ALERT SERVICE BULLETIN

TITLE: Servo-control system - Check of the connection between the upper ball bearing end and the main rotor servo-control

ASB AS365-67-30-0001

Issue 001 2024-04-18
Issue 002 2024-05-15

Figure 1

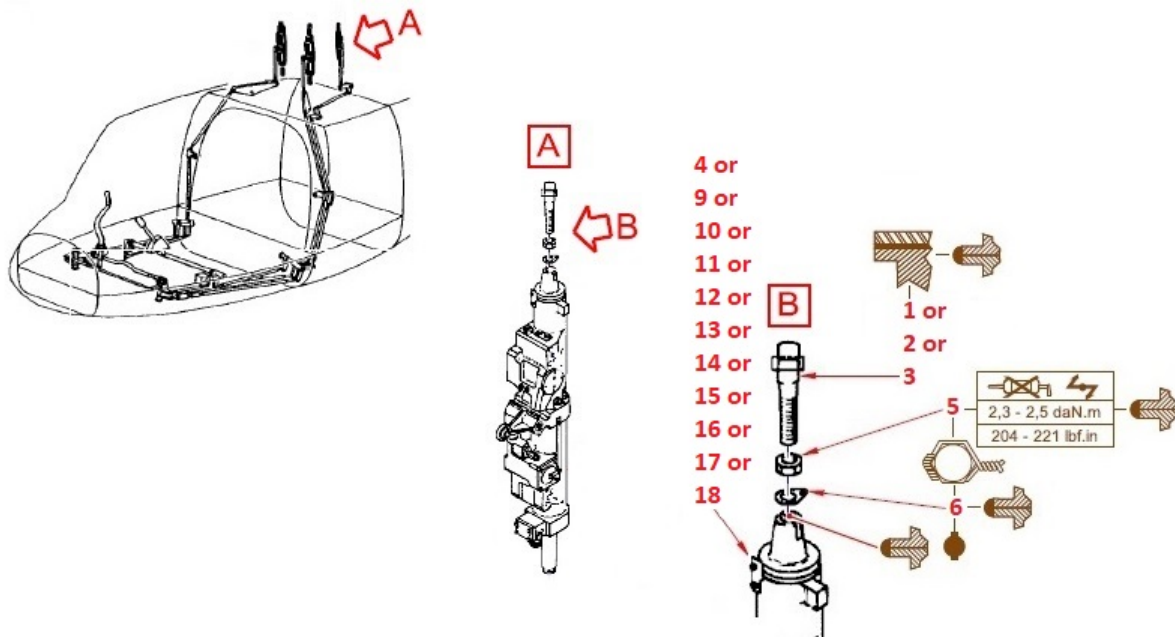
- 4.2. Do a check of the nut (5) tightening torque of the Ball bearing end EMRL8RSP3D (1) or Ball bearing end EMRL8RSP3C (2) or Ball bearing end 6701800800 (3) of the Main rotor servo-control SC8034-2 (4) or Main rotor servo-control SC8034-1 (9) or Main rotor servo-control SC8033-2 (10) or Main rotor servo-control SC8033-1 (11) or Main rotor servo-control SC8032-2 (12) or Main rotor servo-control SC8032-1 (13) or Main rotor servo-control SC8032 (14) or Main rotor servo-control SC8031A (15) or Main rotor servo-control SC8031-2 (16) or Main rotor servo-control SC8031-1 (17) or Main rotor servo-control SC8031 (18)(Figure 1). Refer to Work Card Assembly by screws and nuts - Joining [MTC 20-02-05-404](#).

- 4.2.1. If you get to the minimum torque 2.3 daN.m (204 lbf.in) value before the marks align:
- Torque until the marks align but do not torque to more than the max torque value given in figure 1

- The nut (5)
 - The nut retainer (6)
 - The Lock-wire CM776.
 - Comply with paragraph 4.5.
- 4.2.2. If the tightening torque value is more than or equal to 2 daN.m (177 lbf.in) and less than 2.3 daN.m (204 lbf.in) when you get to the alignment of the marks (corresponds to a loss of tightening torque less than 15% of the minimum torque value):

- The nut (5)
 - The nut retainer (6)
 - The Lock-wire CM776.
 - Comply with paragraph 4.5.
- 4.2.3. If the tightening torque value is less than 2 daN.m (177 lbf.in) when you get to the alignment of the marks (corresponds to a loss of tightening torque more than 15% of the minimum torque value):

- Use Lock-wire CM 776 to safety the nut (5) with the nut retainer (6).
 - Apply a bead of Sealing compound CM 6068 to:
 - The upper end of the Main rotor servo-control SC8034-2 (4) or Main rotor servo-control SC8034-1 (9) or Main rotor servo-control SC8033-2 (10) or Main rotor servo-control SC8033-1 (11) or Main rotor servo-control SC8032-2 (12) or Main rotor servo-control SC8032-1 (13) or Main rotor servo-control SC8032 (14) or Main rotor servo-control SC8031A (15) or Main rotor servo-control SC8031-2 (16) or Main rotor servo-control SC8031-1 (17) or Main rotor servo-control SC8031 (18)

- Torque the nut (5) to the nominal values given in Figure 1.
 - Use Lock-wire CM 776 to safety the nut (5) with the nut retainer (6).
 - Apply a bead of Sealing compound CM 6068 to:

Figure 2

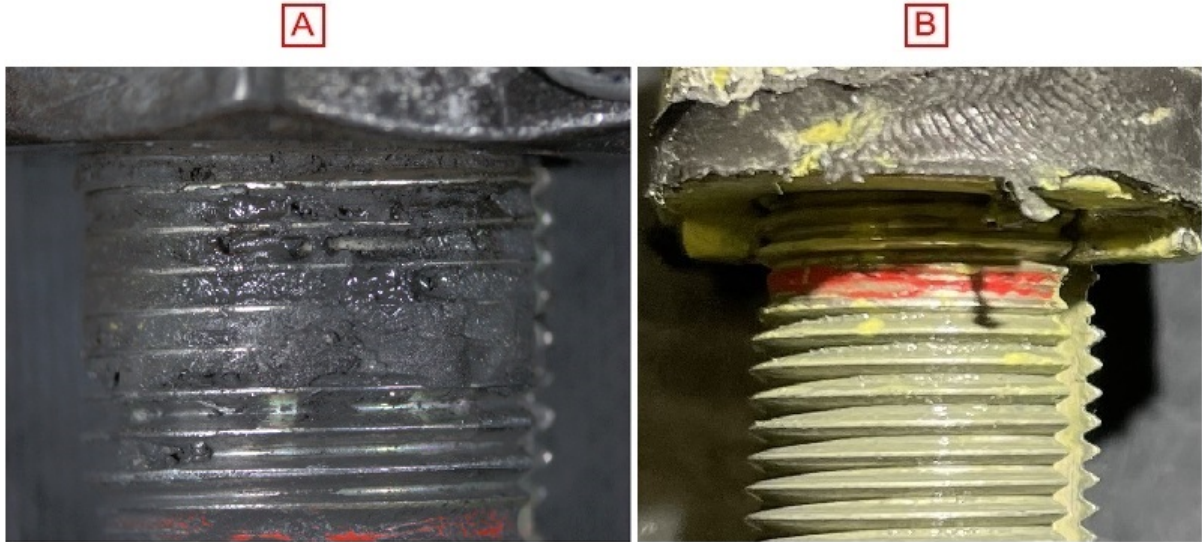
- 4.3.3. Do a detailed visual inspection of threads of the Ball bearing end EMRL8RSP3D (1) or Ball bearing end EMRL8RSP3C (2) or Ball bearing end 6701800800 (3) (Figure 2).

- 4.3.3.1. If there is no dirt, no corrosion and no damaged threads (Figure 2, Detail B):
- Clean the Ball bearing end EMRL8RSP3D (1) or Ball bearing end EMRL8RSP3C (2) or Ball bearing end 6701800800 (3) with Cleaning agent CM 208. Refer to Work Card Use of cleaning products on individual parts and on helicopters - Cleaning [MTC 20-04-01-102](#) Cleaning agent

- Keep the removed Ball bearing end EMRL8RSP3D (1) or Ball bearing end EMRL8RSP3C (2) or Ball bearing end 6701800800 (3).
- 4.3.3.2. If there is dirt (Figure 2, Detail A), corrosion or damaged threads:

- Do photos of the threads
 - Discard the Ball bearing end EMRL8RSP3D (1) or Ball bearing end EMRL8RSP3C (2) or Ball bearing end 6701800800 (3).

Figure 3

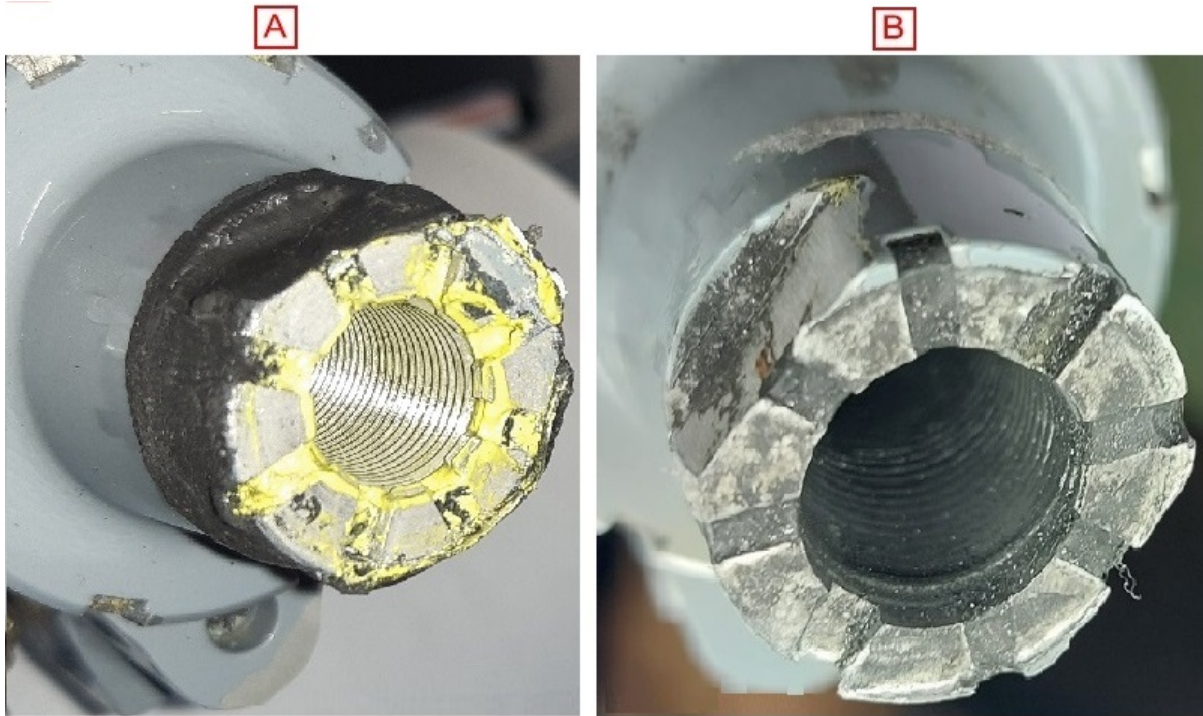
- 4.3.4. Do a detailed visual inspection of the threads on the inner surface of the upper end fitting of the Main rotor servo-control SC8034-2 (4) or Main rotor servo-control SC8034-1 (9) or Main rotor servo-control SC8033-2 (10) or Main rotor servo-control SC8033-1 (11) or Main rotor servo-control SC8032-2 (12) or Main rotor servo-control SC8032-1 (13) or Main rotor servo-control SC8032 (14) or Main rotor servo-control SC8031A (15) or Main rotor servo-control SC8031-2 (16) or Main rotor servo-control SC8031-1 (17) or Main rotor servo-control SC8031 (18) with the Flashlight (7) (not shown) and the Articulated mirror (8) (not shown):

- Do photos of the threads after cleaning.
- 4.3.4.1. If there is oxidation, corrosion or damaged threads (Figure 3, Detail B), comply with paragraph 4.4.

- 4.3.4.2. If there is no oxidation, no corrosion and no damaged threads (Figure 3, Detail A), comply with paragraph 4.3.5.
